BULLETIN

Project Title: UCC Lessner Building 1st Floor Addition & 1st Floor & Lower Level Rehabilitation

Project No: 108813.00

Remarks: Attached please find the following Bulletin_08. Bulletin_08 (drawing G101_R5) includes the details associated with the deletion of the concrete slab extension "blob" at the northern concrete wall and the introduction of a new concrete footing and reinforcement to accommodate the concrete wall.

2 SECTION DETAIL REF SK97C
 SCALE: 1/2" = 1'-0"

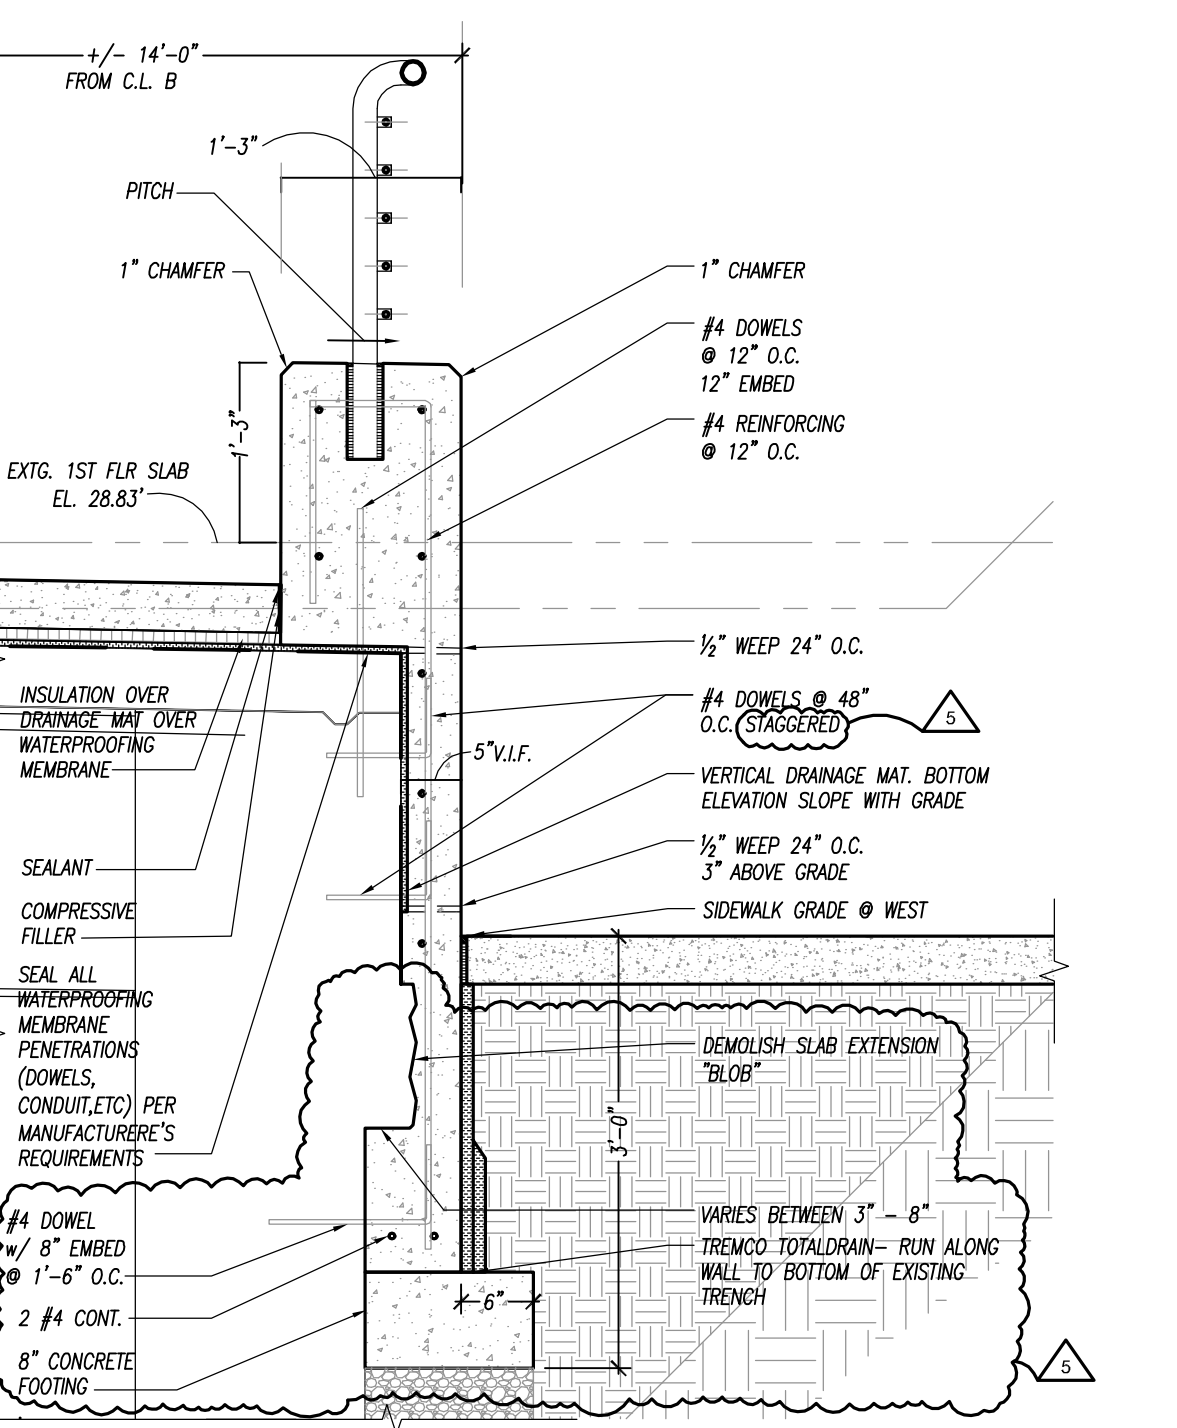
2. Detail 2/G101

- A. Demolish slab extension "Blob"
- B. Add 8" Concrete footing
- C. Add (2)continuous #4 reinforcement
- D. Add 6" compacted fill

3 SECTION DETAIL REF SK97B
 SCALE: 1/2" = 1'-0"

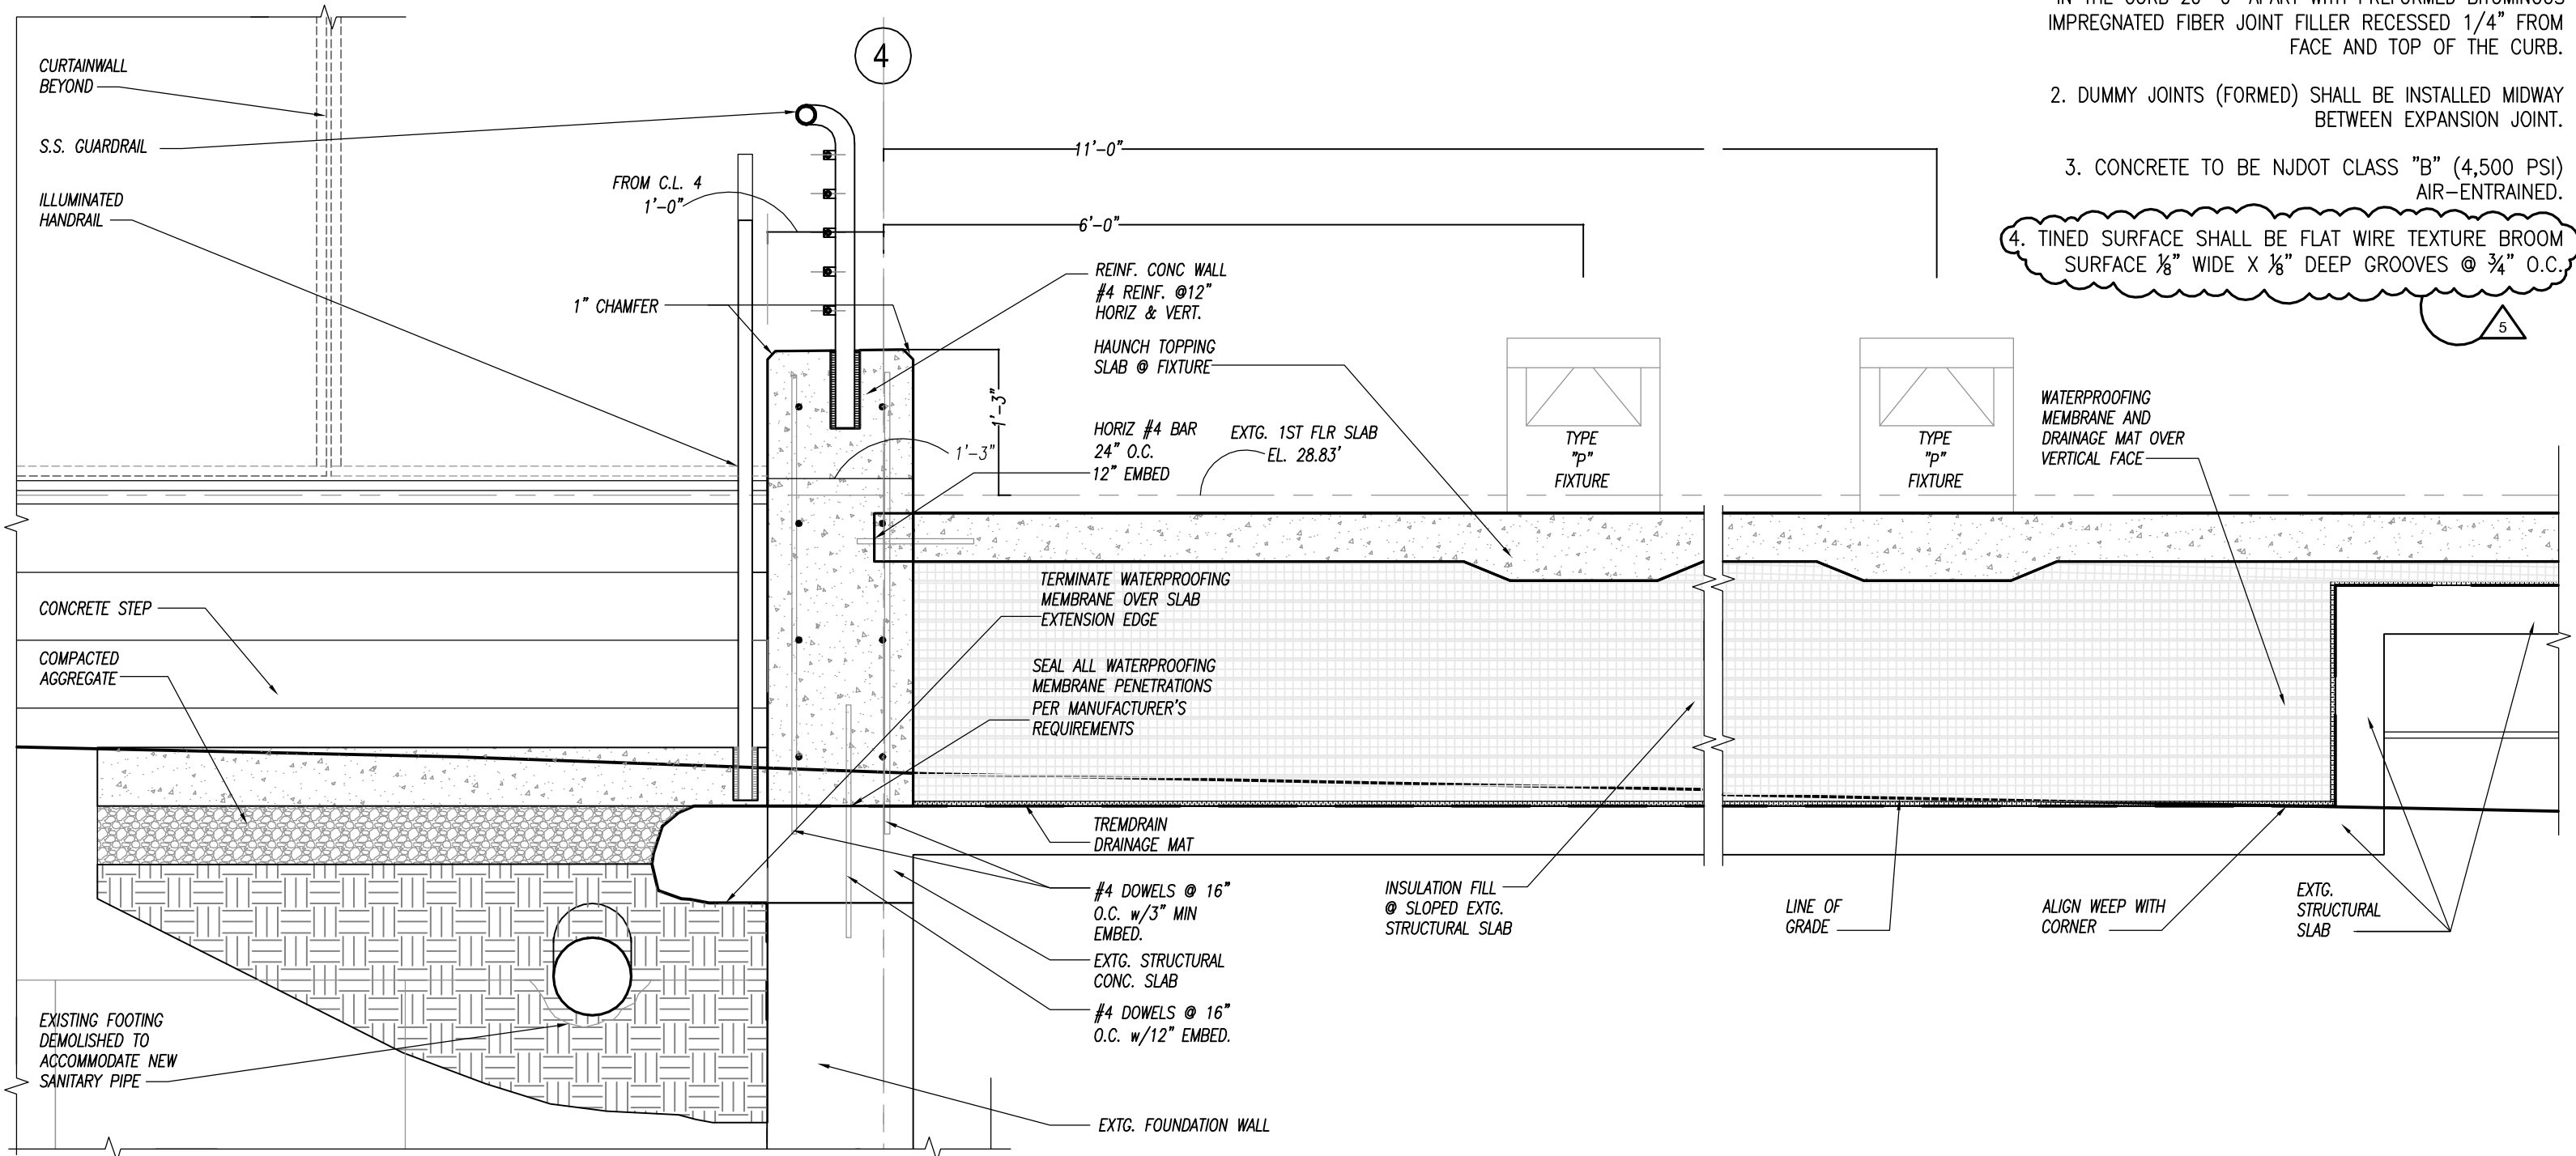
3. Detail 3/G101

- A. Demolish slab extension "Blob"
- B. Add 8" Concrete footing
- C. Add #4 dowel w/8" embed @ 1'-6" o.c.
- D. Add (2)continuous #4 reinforcement
- E. Delete #4 Dowels @ 48" o.c. Add #4 Dowels @ 48" o.c. staggered

5 SECTION DETAIL REF SK97E
 SCALE: 1/2" = 1'-0"

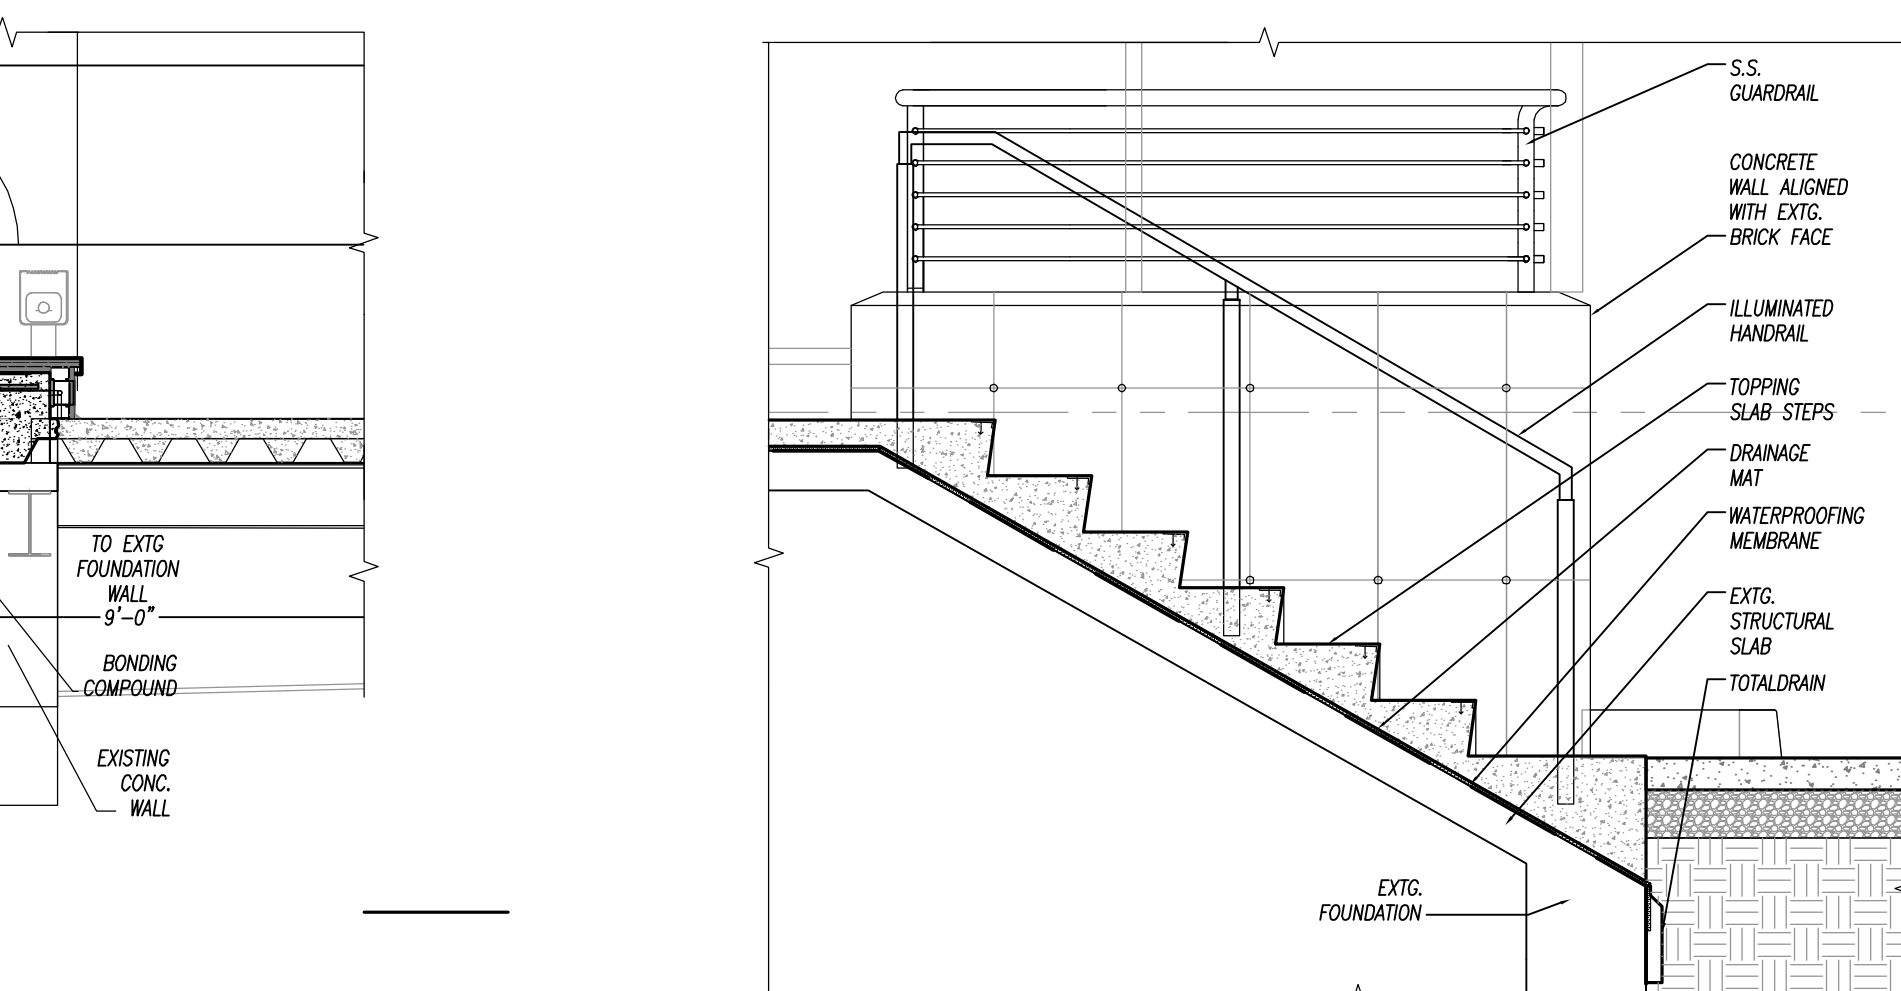
4. Detail 5/ G101

- A. Demolish slab extension "Blob" and existing knee wall. If practical, retain knee wall reinforcement for splice. If not practical, dowel w/8" embed into existing sloped concrete structure.
- B. Add 8" concrete footing
- C. Add #4 dowel w/8" embed @ 1'-6" o.c. into lower foundation wall
- D. Extend wall to footing
- E. Delete 4 signage footings
- F. At west sloped slab condition, add continuous 8" North wall thickness to bear on existing foundation wall with #4 reinforcement @ 12" o.c. Horizontal & Vertical w/ 8" embed into existing foundation
